<b>AMENDMENT OF SOLICITATION/MODIFICATION OF CONTRACT</b>				1. CONTRACT ID CODE <b>J</b>		PAGE 1 OF PAGES 6	
2. AMENDMENT/MODIFICATION NO. 0001		3. EFFECTIVE DATE 7-June-2022		4. REQUISITION/PURCHASE REQ. NO.		PROJECT NO. (If applicable)

14. DESCRIPTION OF AMENDMENT/MODIFICATION (Organized by UCF section headings, including solicitation/contract subject matter where feasible.)  <b>P485 DESIGN BID BUILD, F35 SUPPORT CENTER, MARINE CORPS AIR STATION BEAUFORT, SOUTH CAROLINA</b>   See Continuation Page							
Except as provided herein, all terms and conditions of the document referenced in Item 9A or 10A, as heretofore changed, remains unchanged and in full force and effect.							
15A. NAME AND TITLE OF SIGNER (Type or print)				16A. NAME AND TITLE OF CONTRACTING OFFICER (Type or print)			
15B. CONTRACTOR/OFFEROR (Same as Item 8)  _____ (Signature of person authorized to sign)		15C. DATE SIGNED		16B. UNITED STATES OF AMERICA BY _____ (Signature of Contracting Officer)		16C. DATE SIGNED

The purpose of this amendment is to address Pre Proposal Inquiries and incorporate the following revisions to the General Requirements and Statement of Work:

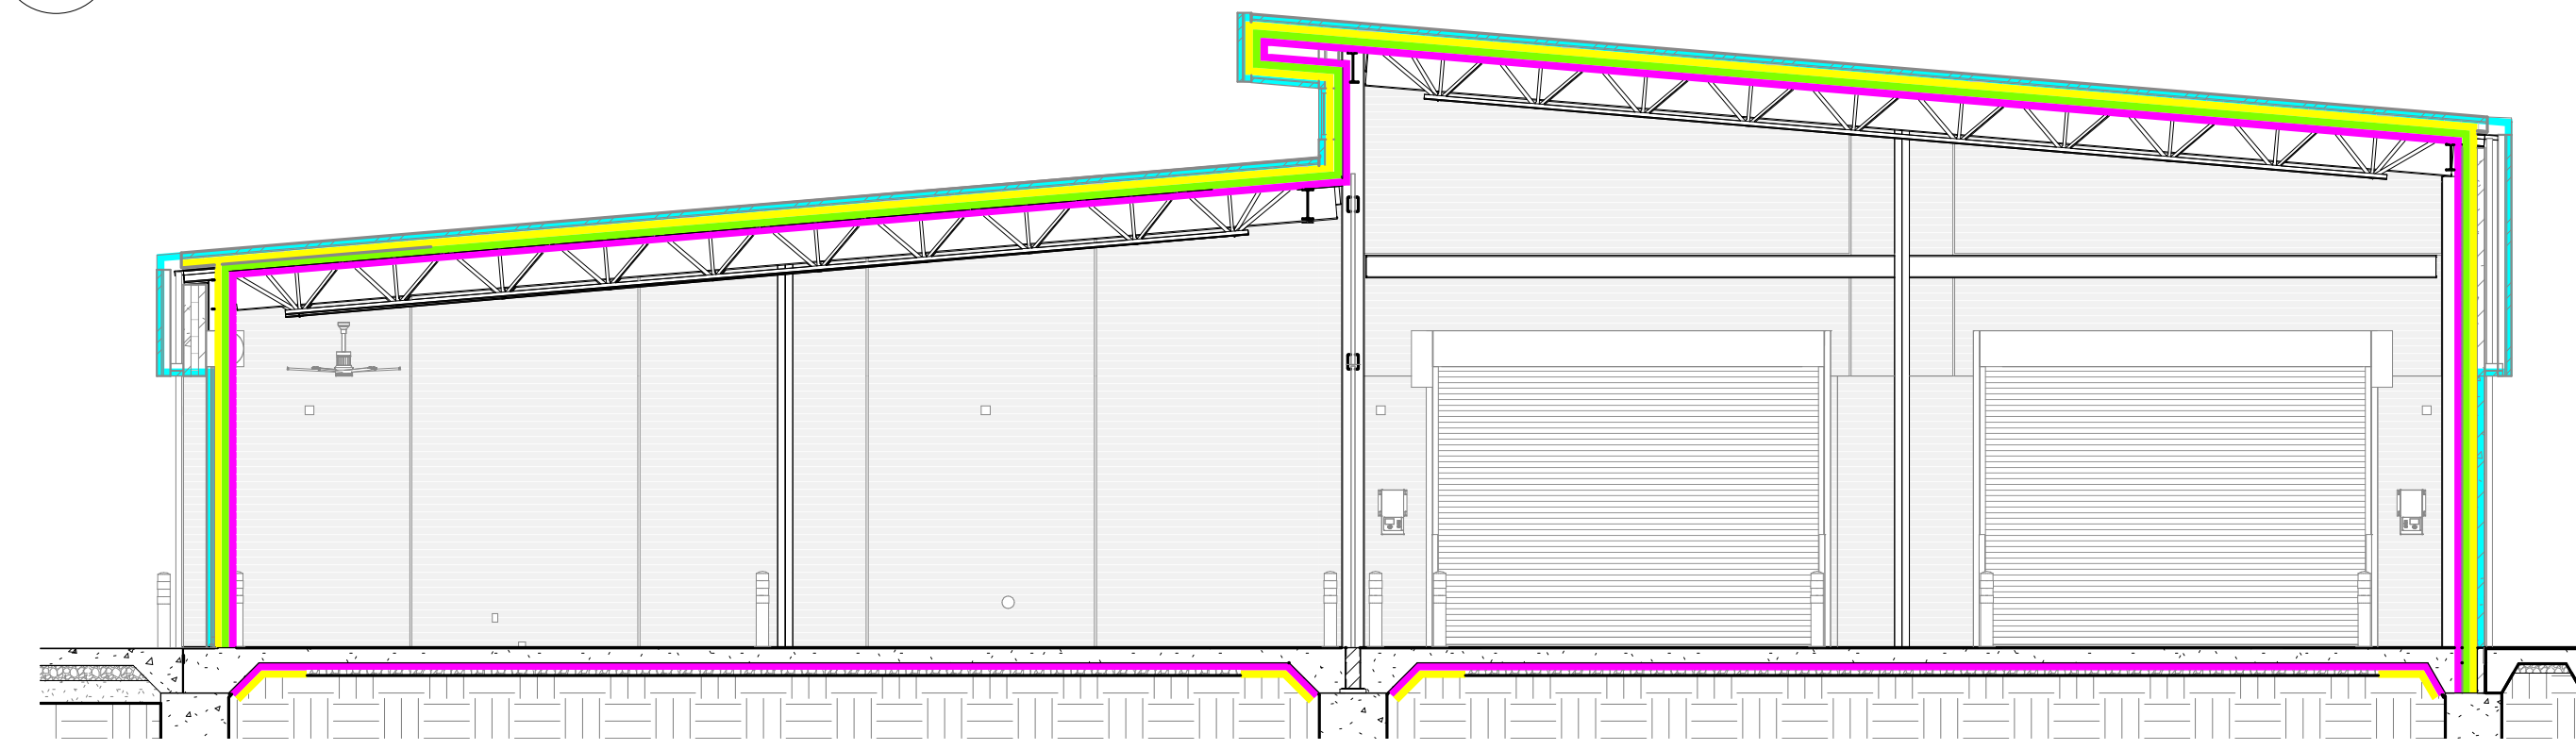
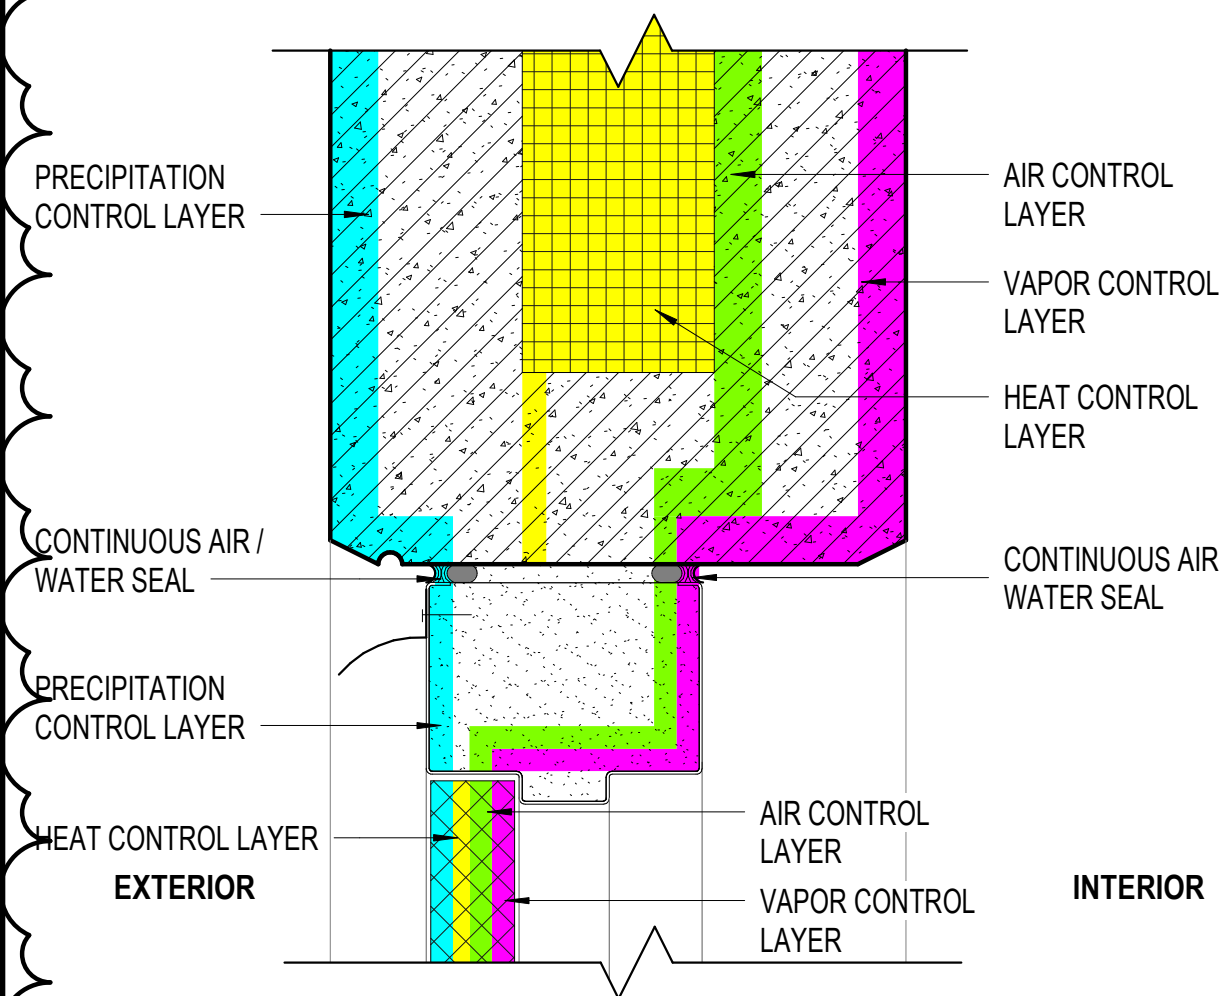
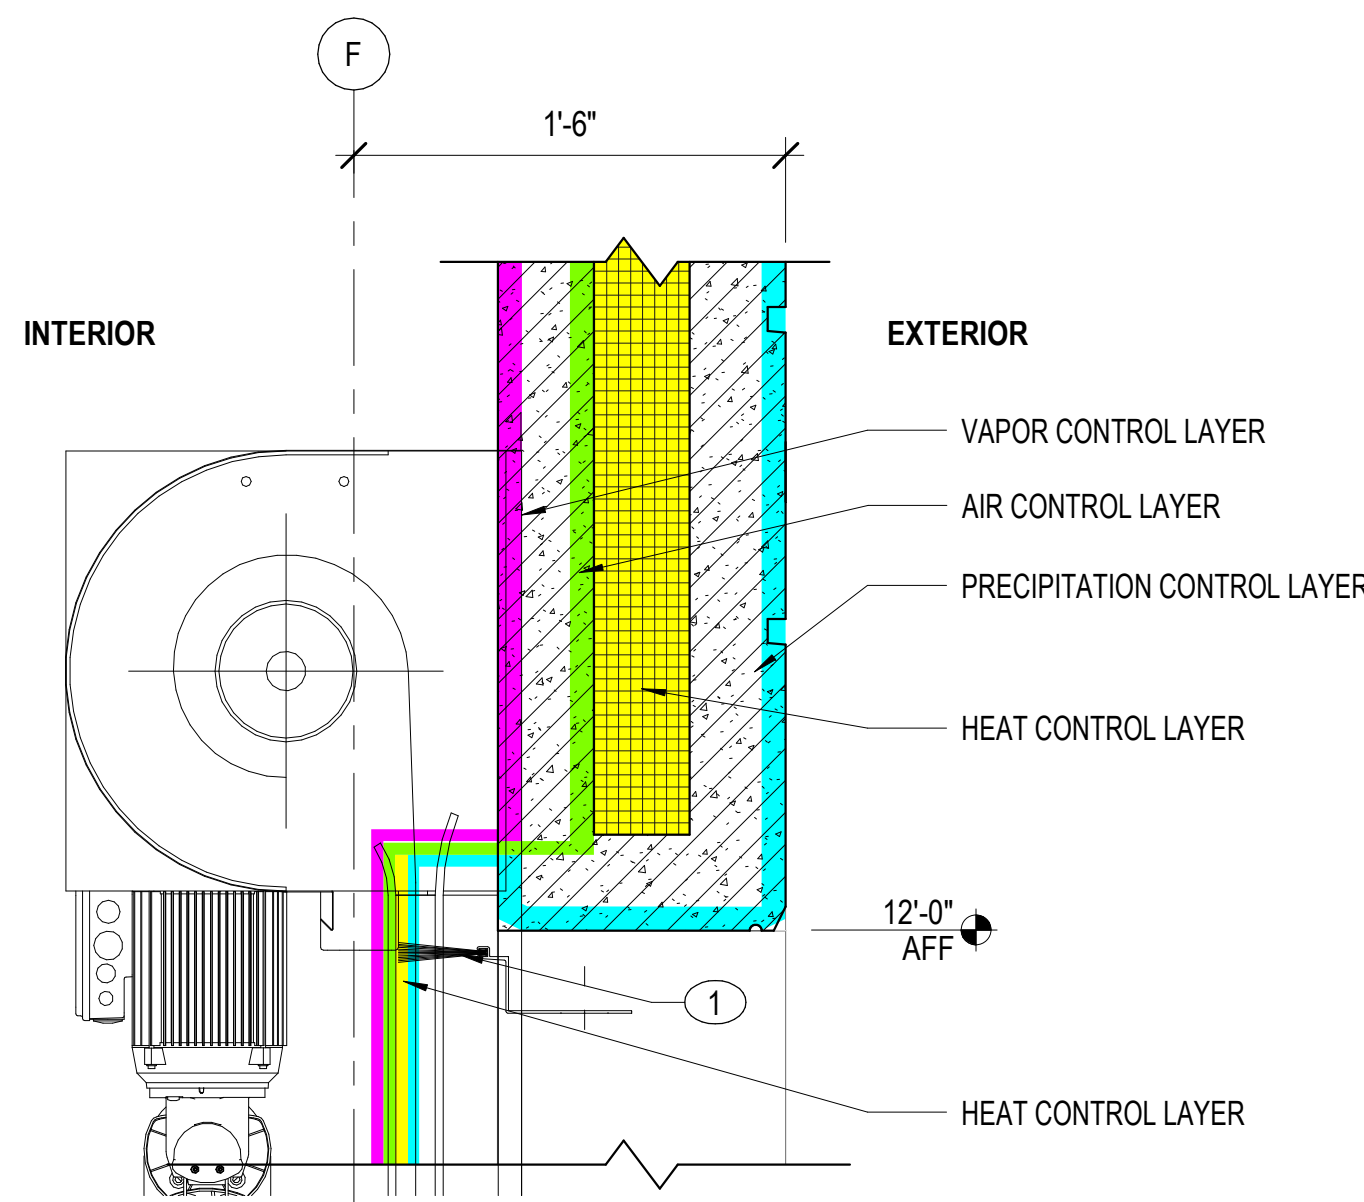
07 05 23		Spec. 07 05 23 stipulates that the contractor must test the air barrier system for air tightness. However, per UFC 3-101-01 all hangar bays, maintenance bays, or similar areas are only required to be inspected and not tested. With the intended use of the facility and the four overhead coiling doors, this facility appears to only require inspection and not testing. Reference Chapter 3, Para. 3-6.3 of UFC 3-101-01. Please confirm that this facility will require air barrier inspection only.	Correct, only inspections of the barrier system are required and not testing per UFC 3-101-01. Spec section 07 05 23 and sheet AE471 and AE472 will be amended.
DWG AE-471			Drawing AE-471, Detail B1 indicates an Air Control Layer, Vapor Control Layer, and Precipitation Control Layer. These items have not been used in precast products before. Please provide more information on what these products are and if they are necessary.	These are not separate materials, but functions created by the precast materials per the PCI standard details for precast. Sheet AE471 and AE472 will be amended for additional clarifications.

- C FULLY SEAL ALL SEAMS, GAPS, AND PENETRATIONS IN THE AIR BARRIER.
- D THE OPERATION SUPPORT FACILITY (OSF) SPACE ONLY REQUIRES AIR BARRIER SYSTEM INSPECTION PER UFC 3-101-01, CHAPTER 3, SECTION 3-6.3. THE OSF IS CLASSIFIED AS A SEMI HEATED, WAREHOUSE FUNCTION.

NOTE 1: AIR BARRIER QUANTITIES ABOVE ARE FOR REFERENCE AND APPLY TO INSPECTION ONLY. REFERENCE UFC 3-101-01, 3-6.3.
